MIL-C-60299A(MU)
AMENDMENT 3
15 March 1972
SUPERSEDING
AMENDMENT 2
27 September 1971

MILITARY SPECIFICATION

CHARGER, BATTERY: 10541243

This amendment forms a part of Military Specification MIL-C-60299A(MU), dated 18 June 1970.

FIG. 1

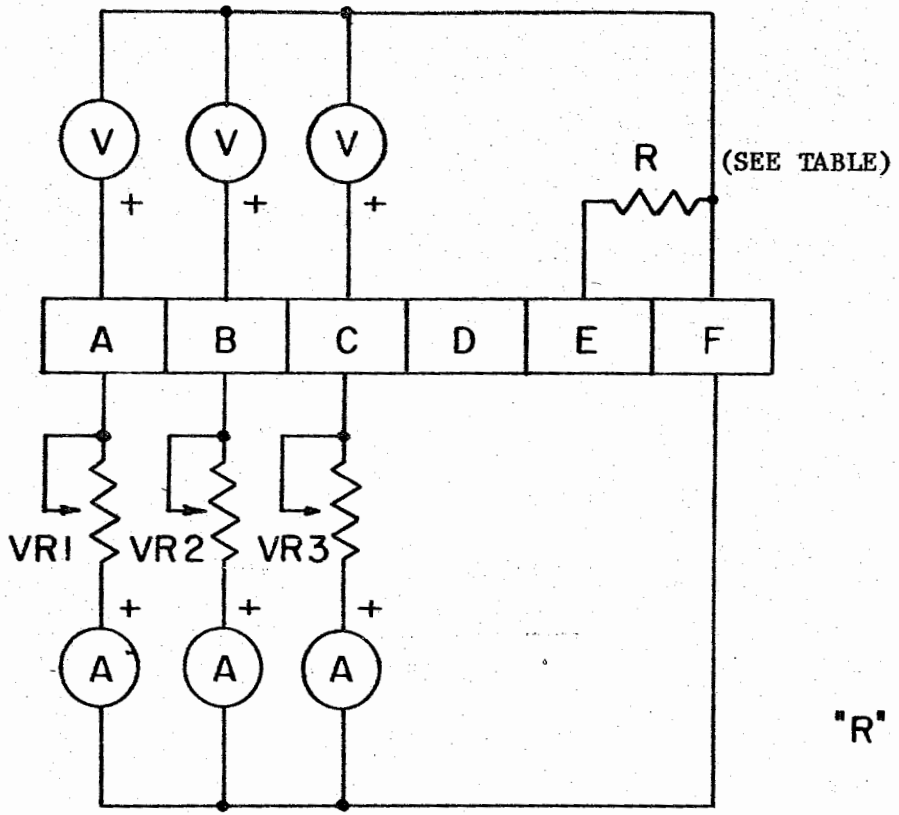
* Figure 1: Delete lines connected to pin "D"; connect lines to pin "F".
